TO: Mercedes-Benz Dealer Principals, General Managers, Sales Managers, Service Managers, Parts Managers	FROM: Gregory Gunther, Senior Manager, Vehicle Compliance and Analysis, Engineering Services
RE: Recall Campaign Launch Notification Check Acceleration Sensor Wiring Harness Routing MY21-22 GLE (167 platform)	DATE: October 19, 2024

Campaign No. 2024100006, October 2024

SUBJECT: **Model GLE (167 platform)**
Model Year 2021 – 2022

Check Acceleration Sensor Wiring Harness Routing

Figure 2

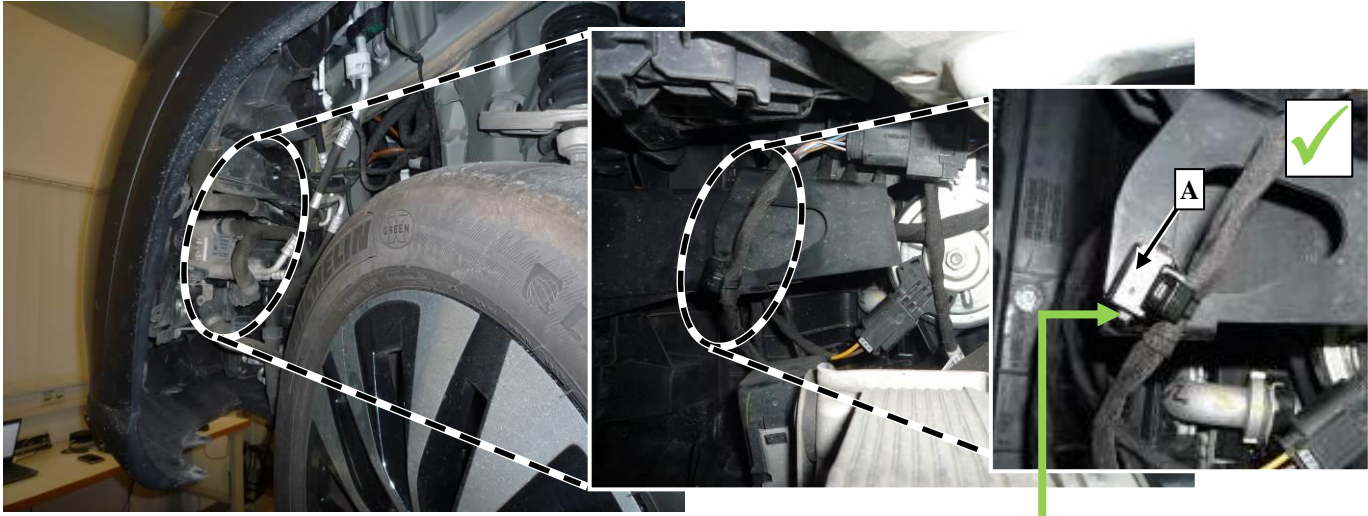
2. Check the wiring harness bracket (**Figure 2, A**) for the frontal acceleration sensor to ensure it is assembled correctly.

i Correct assembly position: (**Figure 2, A**).
 Incorrect assembly position: (**Figure 3, B**).

- a. Wiring harness bracket **correctly** (**Figure 2, A**) installed: **End measure**.
- b. Wiring harness bracket **incorrectly** (**Figure 3, B**) installed: Perform **Work Procedure**.

1. Remove front bumper.
i For basic data, see AR88.20-P-2000ME.
2. Fit wiring harness bracket correctly as shown (**Figure 2, A**).
i Wiring harness bracket is attached to the existing tab (**Figure 3, A**).
3. Assemble in reverse order.
